## Cumberland Council Draft Walking and Cycling Strategy Feedback

Thank you for the opportunity to comment on the Cumberland Council Draft Walking and Cycling Strategy (referred to in this document as 'the Strategy').

These comments have been prepared on behalf of CAMWEST, a Bicycle NSW affiliated Bicycle User Group with a focus on advocating for and encouraging cycling in the Penrith, Blacktown, Parramatta, and Cumberland council areas of Western Sydney.

## Corridor 7 (Prospect Pipeline Corridor to Olympic Pk via Berala):

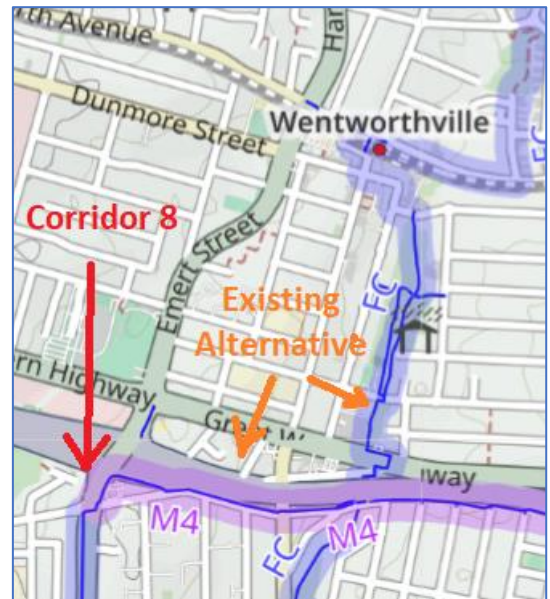
- Although defined as a partially completed corridor, there appears to be virtually no off-road sections completed south of the Adderley St shared path alongside the M4.
- As mentioned in previous correspondence with Council <sup>[5]</sup>, we have some safety concerns with the crossing of Silverwater Rd and Stubbs St along the Adderley St shared path.
- A lot of the route is outlined as 'General Roads' on the Cycleway Finder webpage <sup>[6]</sup>. We're not currently familiar enough with the roads from Auburn Town Centre moving south to make further meaningful comment.

Suggested Bridge across Prospect Ck and southernmost 100m shared path of Corridor 9 alongside Fairfield Rd

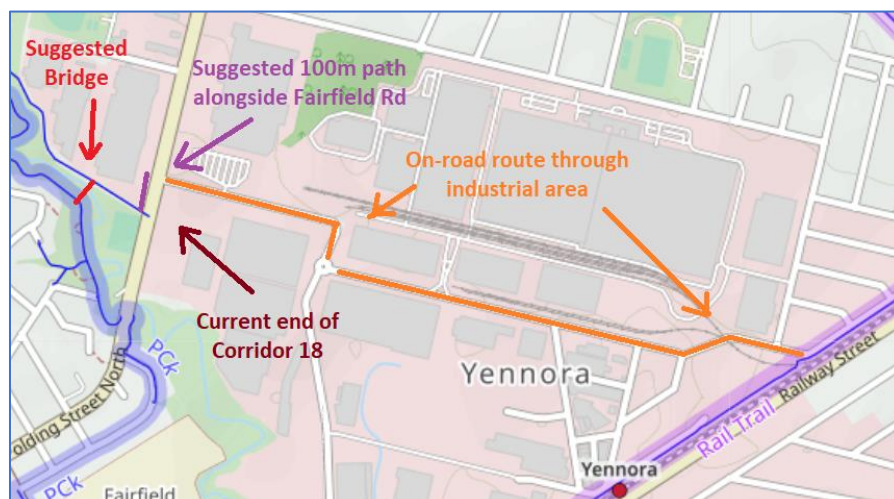
- As mentioned in our feedback for the Prospect Pipeline Corridor Masterplan <sup>[1]</sup>, CAMWEST are keen for the connection between Finlaysons Ck and the Prospect Canal path, which Corridor 9 incorporates (partly because this is an easier to ride and more pleasant alternative to Corridor 8 alongside the Cumberland Hwy).

- As also mentioned in the above Masterplan feedback, we would be keen to see a route to the Woodpark shops. The anticipated route of Corridor 9 goes closer to the shops than the Canal path but doesn't quite reach them. A 'local' route would help solve this issue.

- As mentioned in comments for Corridor 18 below, we would be keen for an extension of Corridor 9 across the Prospect Ck to join up with an existing path on the southern side of the creek (in Fairfield LGA) which would effectively continue Corridor 18 into Fairfield and join it up with the Rail Trail (Corridor 5). The existing path alongside Fairfield Rd is too narrow to fulfill the function of joining the two existing paths via shared path.

- Constructing the southernmost 100m or so of Corridor 9 between the shared path and the Dursley Rd traffic lights would provide some utility to riders. Dursley, Pine, Loftus and Military Roads in Yennora provide a reasonable on-road 2km route to the Rail Trail – particularly on weekends when there is reduced vehicular movements in this industrial precinct.

Map showing the winding path on the southern side of Prospect Ck (Fairfield LGA) compared to the more direct path on the northern side within the Cumberland LGA.

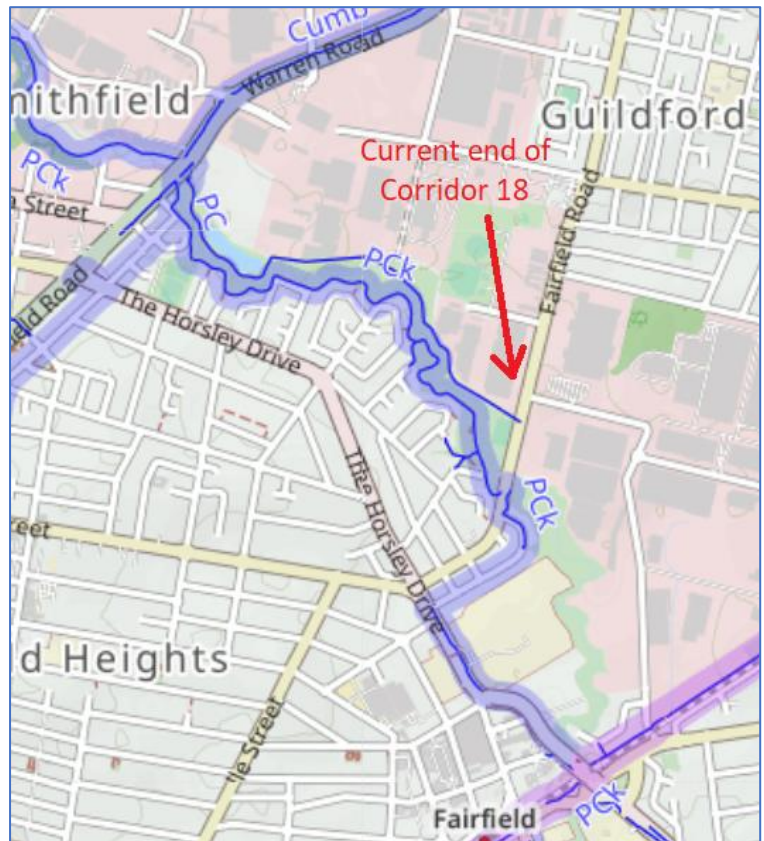
One of the ramifications of not showing existing paths in neighbouring LGAs is that the eastern end of this path appears to go nowhere. On the southern side of the creek there is a reasonable connection to Fairfield and the extension of Corridor 5 (Parramatta to Fairfield Rail Trail). While the existing path on the northern side of Prospect Ck between Cumberland Hwy and Fairfield Rd (in Cumberland LGA) is a lot more direct and quicker to ride, when riding this route, we normally use the southern side in of the creek in the Fairfield LGA as the connectivity between Fairfield and Cumberland Hwy is a lot better<sup>[7]</sup>.

We'd love to see a new bridge built over Prospect Ck just west of Fairfield Rd, so we could use the quicker route in Cumberland LGA then cross to the southern side for connectivity to Fairfield. This is mentioned as a possible extension of Corridor 9.

Route along Alexandra Ave and Park Parade mentioned in the Parramatta Bike Plan which doesn't appear to be mentioned in the strategy.

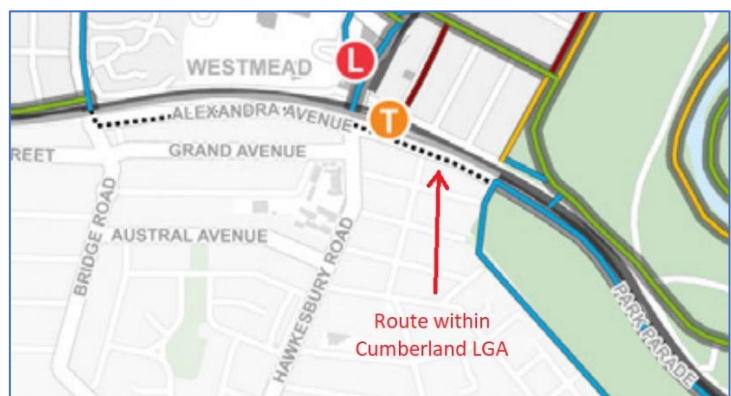
There appears to be a couple of omissions in the strategy when comparing with the Central River City Cycleway Corridors.

- The strategy omits the corridor from Regents Park to Rookwood, and
- The strategy doesn't include the Toongabbie to Westmead Corridor. We note that the Parramatta Bike Plan includes the link along the northern side of the railway corridor between Toongabbie Station and Bridge Rd, Westmead. However, their bike plan indicates that Cumberland Council is handling the section east of Bridge Rd along Alexandra Ave to the east of Westmead Station.

Why was this omitted? Is it too 'low level' to be displayed as a strategic route or part thereof?

*Marked up section of the Strategy with additional routes added.*

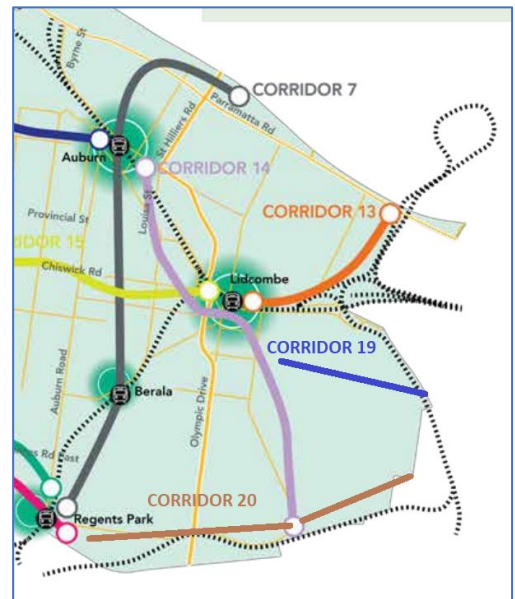
- As mentioned above in Corridors 9 and 18, a bridge across Prospect Ck to join to the existing path which leads into Fairfield would be a very welcome addition.

- Lidcombe to the east side of Rookwood, labelled here as Corridor 19. Note that while it is probably faster and more enjoyable to ride through Rookwood during daylight hours, a path around the perimeter should be strongly considered for when the gates to Rookwood are closed (or for those riders who may feel uneasy about riding through the cemetery). This could link into the existing combined shared path and on-road route between Sydney Olympic Park and the Cooks River shared path.

- Regents Park to Cooks River path, which I've label here as Corridor 20. This could link in directly with the Cooks River shared path.
- In a previous discussion with a Council staff member, we heard that investigations were underway into the possibility of a bridge across Olympic Drive at Wyatt Park. If this is still an option, I don't see this really reflected in any of the corridors.
